RESPONSE TO REQUEST FOR ADDITIONAL INFORMATION

APR1400 Design Certification

RAI No.: 491-8613

Question No. 09.05.02-5

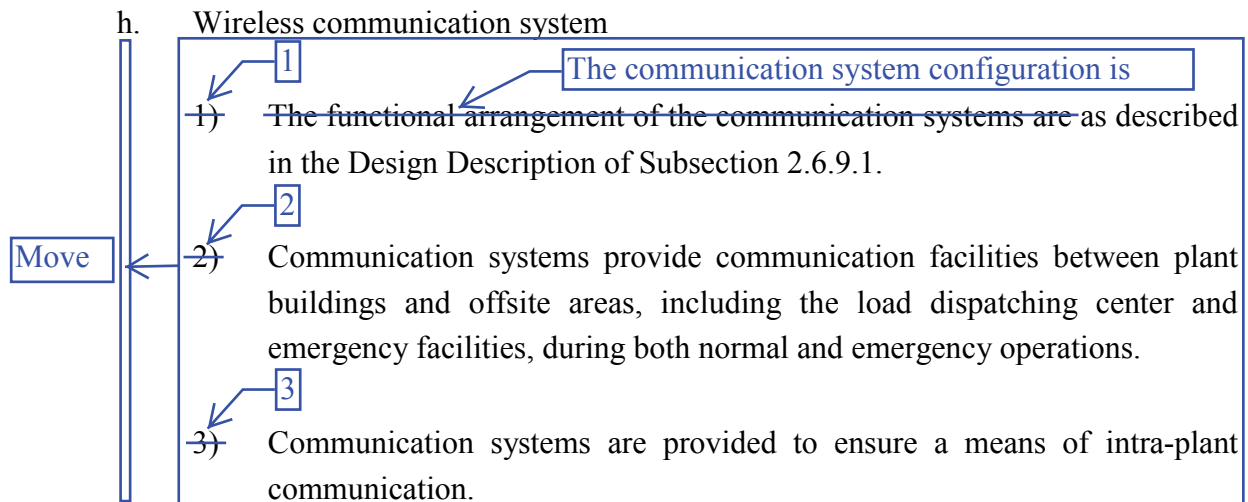
- (a) The applicant needs to clarify what they mean by functional arrangement of communication systems. A definition for functional arrangement of communication systems in APR1400 FSAR Tier 1, Section 2.6.9 is needed. Update FSAR documents accordingly.

- (c) There is a inconsistency between the items in the list provided in APR1400 FSAR, Tier 1, Rev 0, Section 2.6.9.1, "Design Description" and APR1400 FSAR, Tier 2, Rev 0, Section 9.5.2.2, "System Description". These sections describe in part, the buildings within the APR1400 facility which contain communication systems. APR1400 FSAR, Tier 1, Rev 0, Section 2.6.9.1 needs to include all the buildings provided in APR1400, Tier 2, Rev 0, Section 9.5.2.2. Similarly Section 2.6.9.1 mentions "Page Phone System" while Section 9.5.2.2 mentions "Paging phone system". APR1400 FSAR, Tier 1, Rev 0 information needs to be corrected and updated in both these instances such that information is consistent between Tier 1 and Tier 2 of the FSAR.

- (a) There is editorial error in DCD Tier 1, Subsection 2.6.9.1. Design description 1), 2), and 3) are not sub-descriptions of DCD Tier 1, Subsection 2.6.9.1.h, "Wireless communication system". In this subsection 2.6.9.1, the configuration of communication system is described. Thus "the functional arrangement" will be changed with "the communication system configuration". DCD Tier 1, Subsection 2.6.9.1 will be revised.

- (c) For consistency between DCD Tier 1 and Tier 2, DCD Tier 1, Subsection 2.6.9.1 and Tier 2, Subsection 9.5.2.2 will be revised.
